SERVICE BULLETIN

SB07-0001

Subject: KM-501MAH DIP SWITCH SETTING CHANGE.

DIP Switch location.

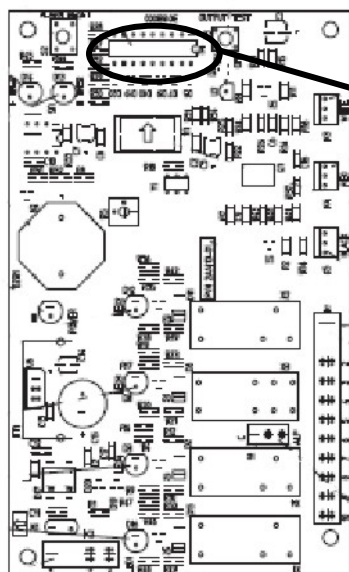
Effective December 2006 the factory setting for DIP switch numbers 1 and 2 have been changed for the KM-501MAH series of ice makers. The new setting is DIP switch number 1 in the OFF position and number 2 in the ON position. This will change the defrost completion time from 60 seconds to 120 seconds.

If you are experiencing freeze up issues on these units, we are suggesting that a freeze up check list be completed (SB03-0003) If no other problems which could cause a freeze up are found, you should adjust DIP switch 1 and 2 to the new factory setting shown above.

A good rule of thumb would be to adjust these DIP switches to the new setting any time you are servicing or performing preventative maintenance on a KM-501 produced before December 2006. Serial numbers (R_ _ _ _N)
